Intel® Mobile Pentium® III Processor Specification Update

Release Date: September 2000

Order Number: 245306-011

Figure 7. BCLK Timing Waveform

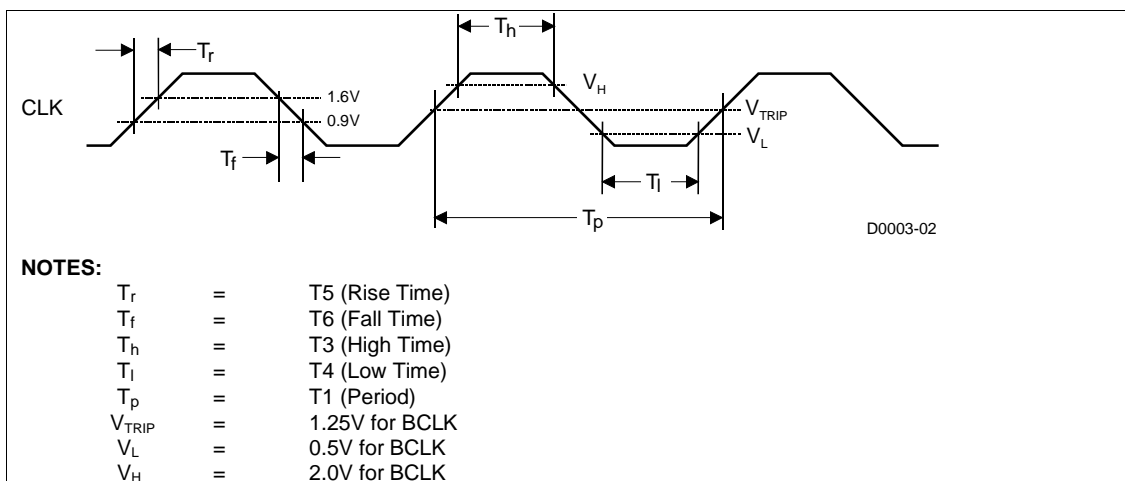
For B0 step processors, the $V_{IH,BCLK}$ Min spec is changed to 2.0V (from 1.7V for A2 step) and $V_{IL,BCLK}$ Max spec is changed to 0.5V (from 0.7V for A2 step). Due to this, new values are specified for BCLK high and low times for B0 step processors. These modifications affect corresponding specs in Table 13, Table 14, Table 24, and Figure 7 in *Mobile Pentium® III Processor in BGA2 and Micro-PGA2 Packages datasheet* (Order Number 245302-002).

The following tables and figures highlight the above mentioned BSEL[1:0] and BCLK specs modifications made for B0 step processors:

Symbol	Parameter	Min	Typ	Max	Unit	Figure	Notes
	System Bus Frequency		100		MHz		
T1	BCLK Period		10		ns	Figure 7	Note 2
T2	BCLK Period Stability			± 250	ps		Notes 3, 4
T3	BCLK High Time	2.70			ns	Figure 7	at >2.0V
T4	BCLK Low Time	2.45			ns	Figure 7	at <0.5V
T5	BCLK Rise Time	0.175		0.875	ns	Figure 7	(0.9V – 1.6V)
T6	BCLK Fall Time	0.175		0.875	ns	Figure 7	(1.6V – 0.9V)
